### **ADDENDUM #1**

Reference: Department of Human Services

Richfield Family Support Services Remodel

DFCM Project No. 05129400

## **DENDA DRAWING 01**

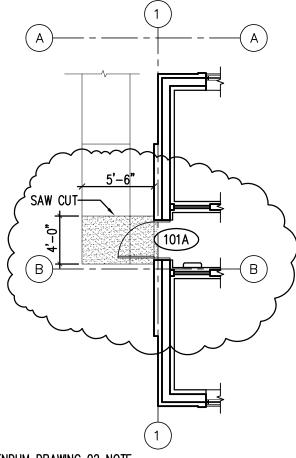
- 3. See attached  $8 \frac{1}{2}$  × 11" addendum drawing 01. Note changes to size of concrete stoop and the addition of a steel lintel that will be required over door 107A

1. DOOR 107A SHALL HAVE A STEEL LINTEL PROVIDED OVER DOOR OPENING AS PER DETAILS 1 AND 2 ON DRAWING S-GN100.

### **ADDENDA DRAWING 02**

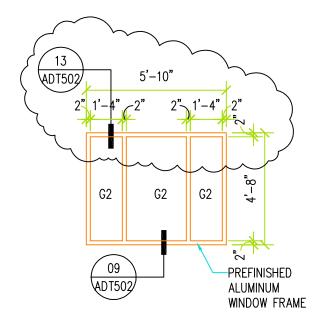
- 4. See attached 8 ½" x 11" addendum drawing 02. Note changes to size of concrete stoop located at the exterior of door 101A
- 5. See attached 8  $\frac{1}{2}$ " x 11" addendum drawing 03. Note change to size of window type 10

- 1. GENERAL CONTRACTOR SHALL REMOVE EXISTING CONCRETE SIDEWALK AT LOCATION WHERE NEW CONCRETE STOOP IS TO BE LOCATED.
- 2. TOP OF NEW CONCRETE STOOP IS TO BE SET AT SAME HEIGHT AS EXISTING BUILDING FLOOR SLAB.
